STAFF REPORT: 02-10-2021 MEETING

APPLICATION NUMBER: 21-7050

ADDRESS: 1201 WASHINGTON BOULEVARD

SCOPE: DEMOLISH PORTION OF BUILDING AT REAR; REPLACE NON-HISTORIC STOREFRONTS, ROOFTOP ADDITIONS

1ST FLOOR DEMOLITION PLAN

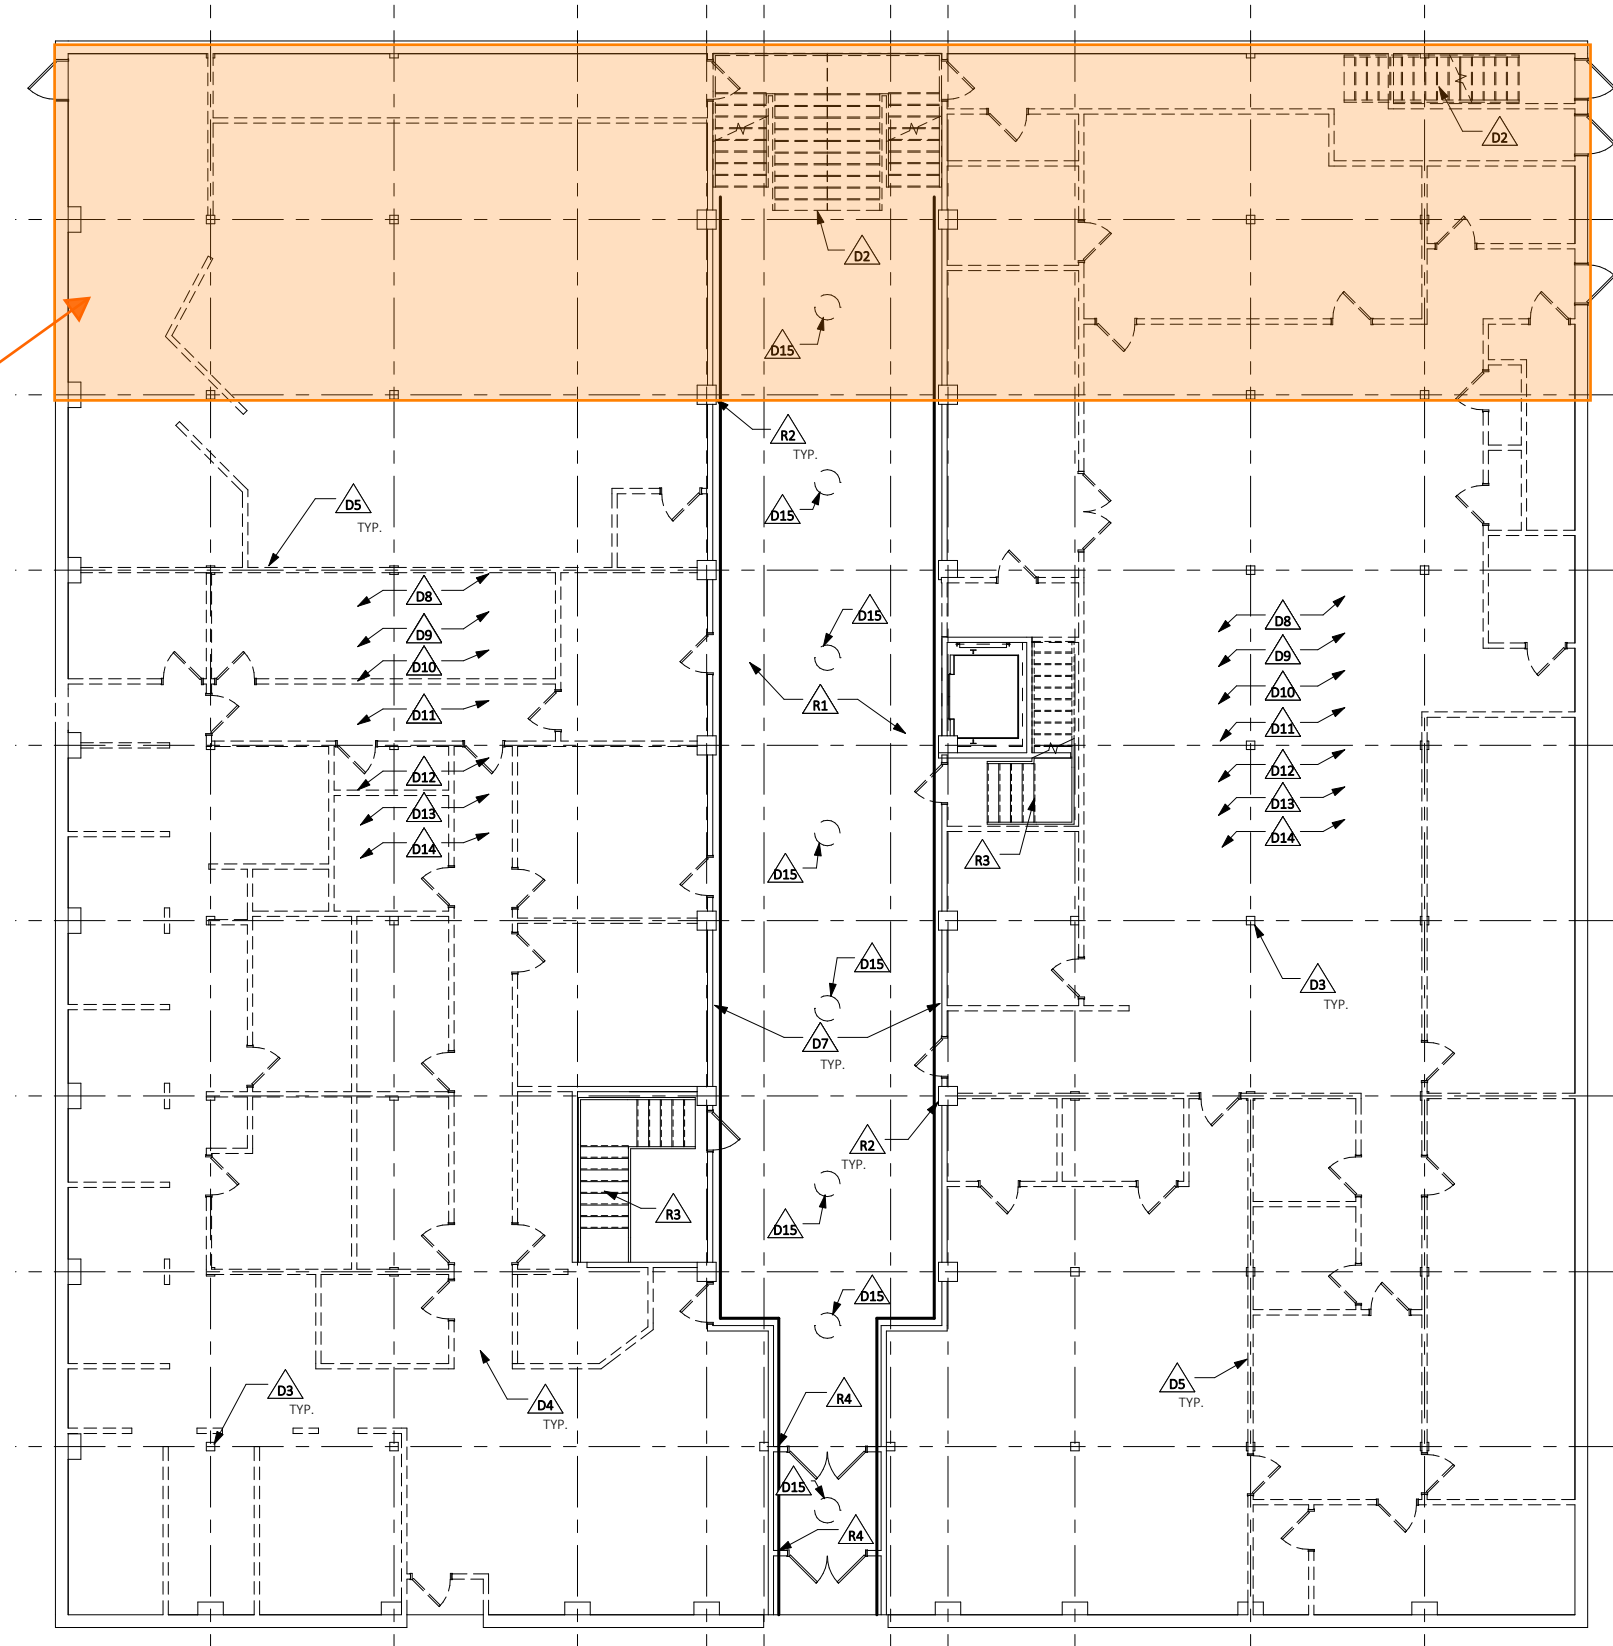
Demolition

- Remove two bays at the westernmost end of the State Street elevation to create a continuous alley behind the Book Tower, Book Building and Book Tower Arcade.

- BZA documents submitted to HDC do not show any mention of the need to demolish a portion of 1201 Washington in order to obtain access for a second loading zone.

ROOF PLAN

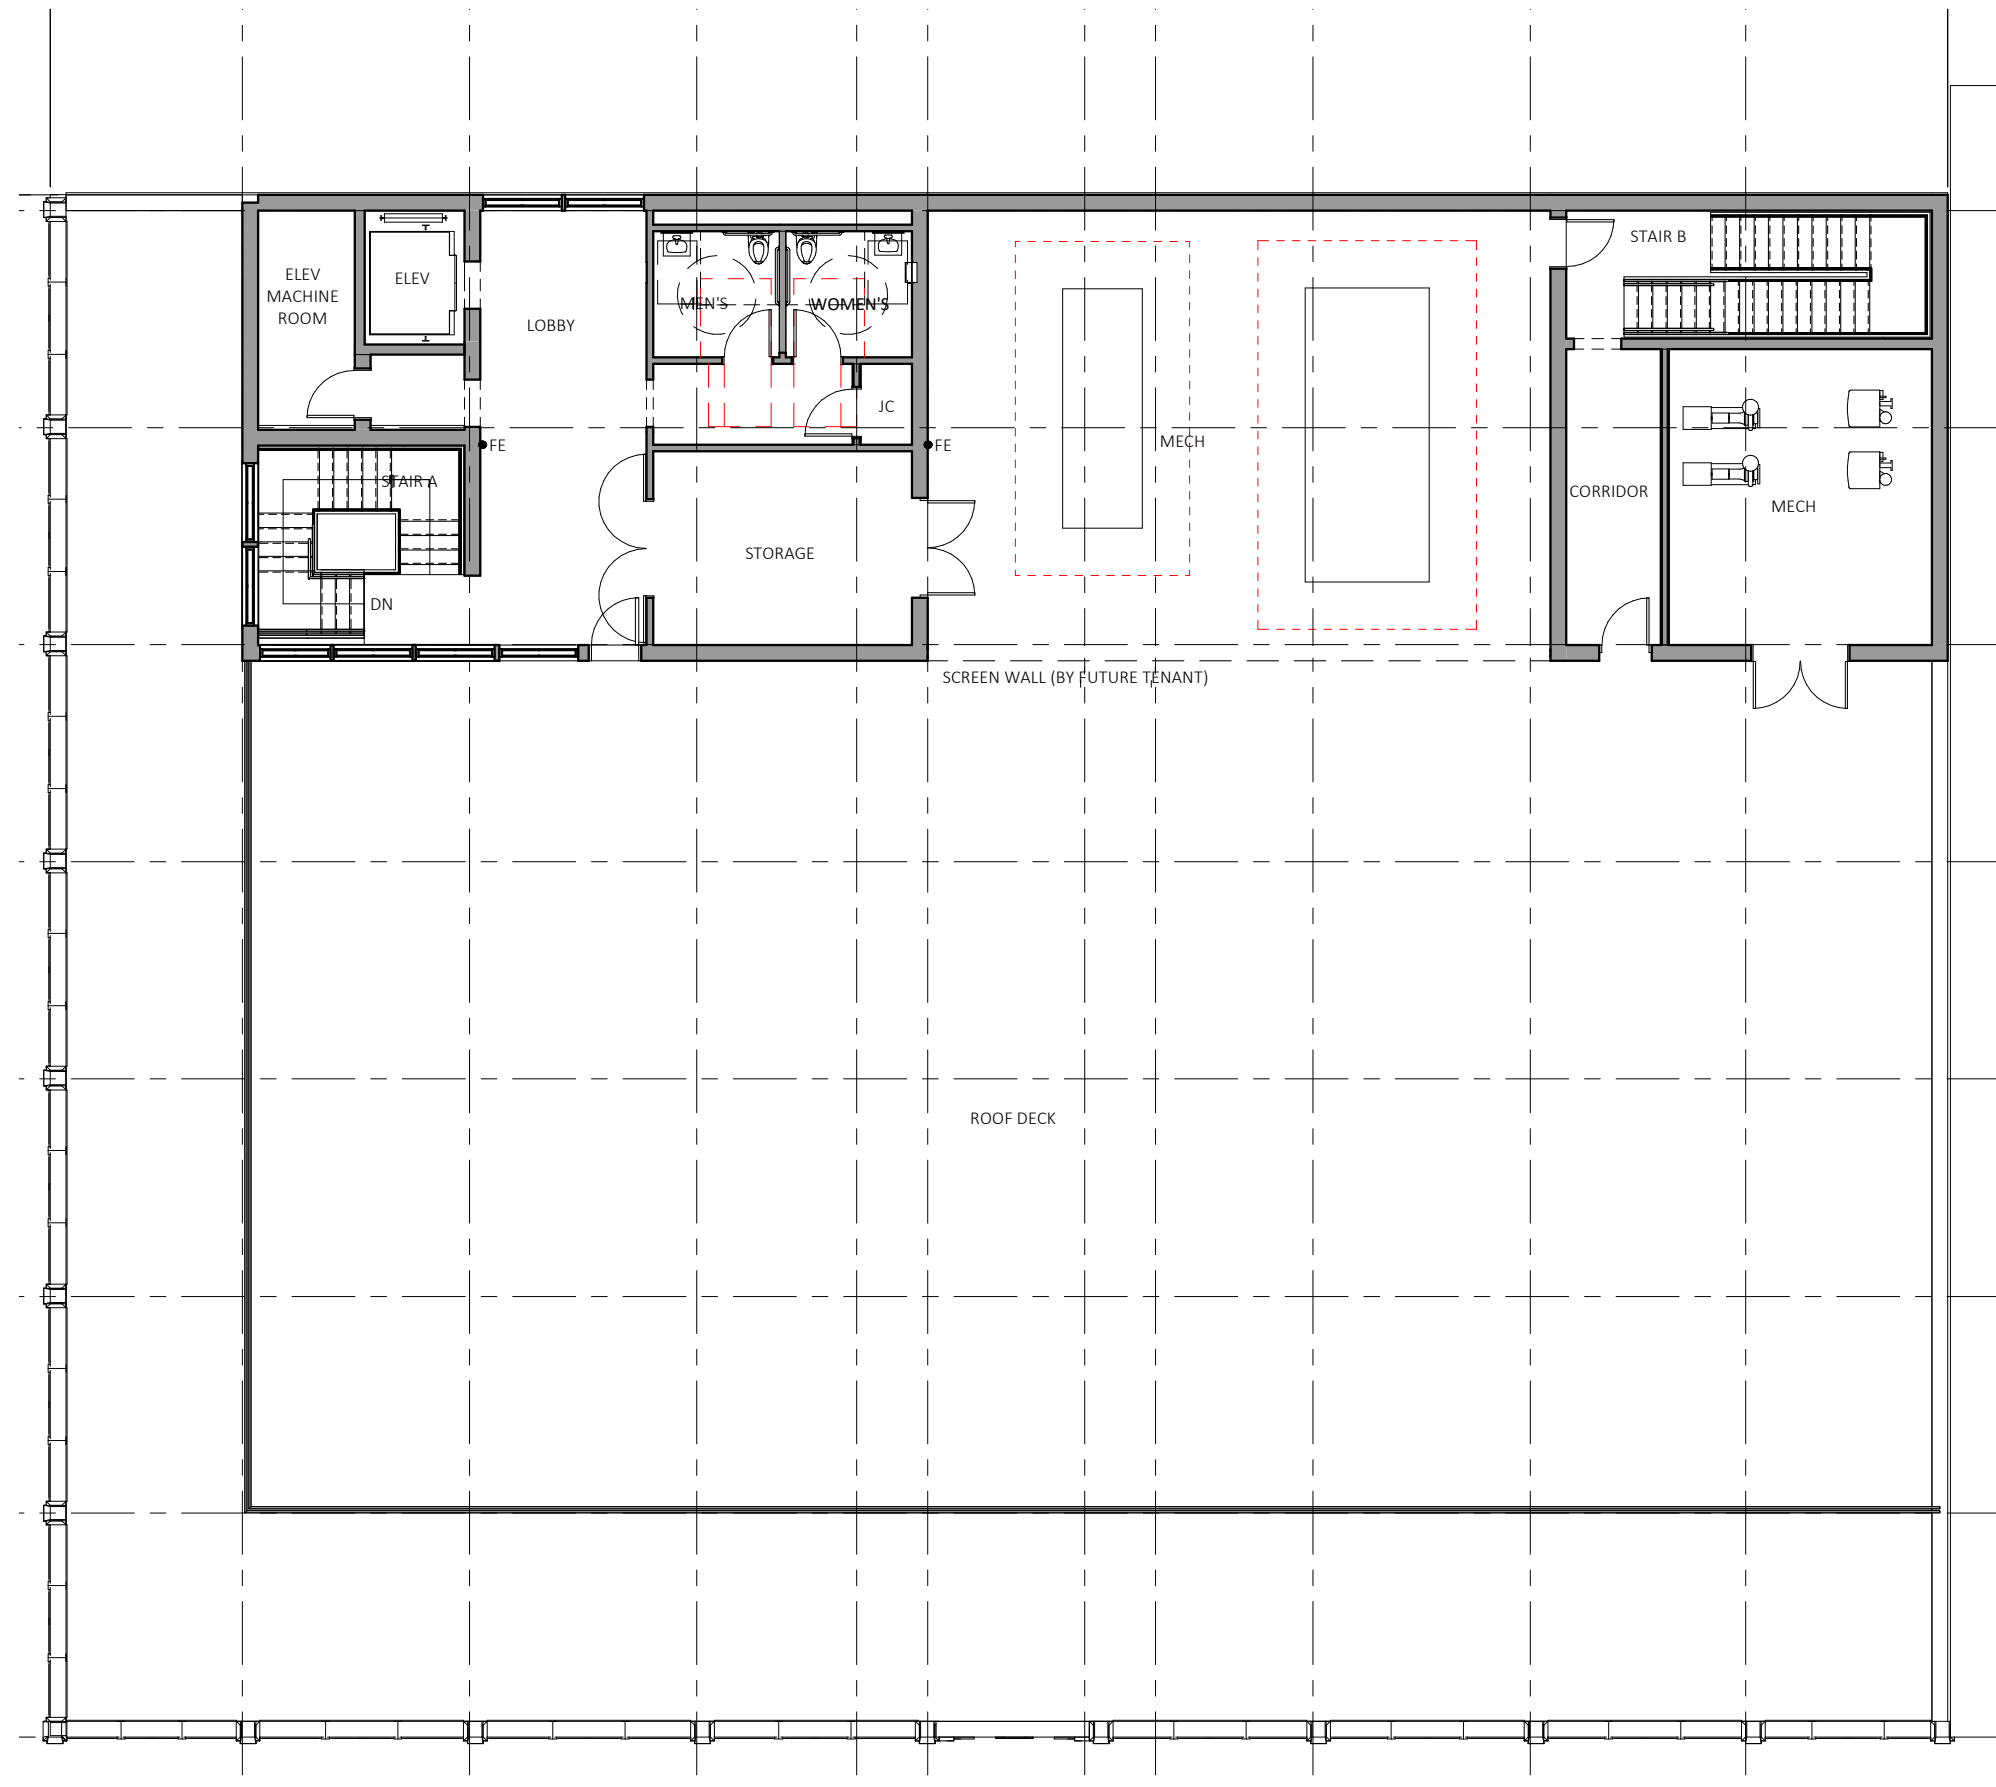
- The south penthouse will provide stair and elevator access to the new roof deck, along with storage and convenience restrooms. The north penthouse will provide stair access to the new roof deck and a building mechanical room. *Needed: Detailed and dimensioned elevations, penthouse wall section*

- Rooftop mechanical equipment will be kept to the westernmost edge of the roof, along the new alley.
 - The rooftop equipment will be shorter than the two new penthouses. *Needed: Catalog cuts confirming equipment and its dimensions.*

- A brick wall or parapet will help screen the rooftop equipment from the alley. *Needed: This should be shown on the new exterior wall section.*
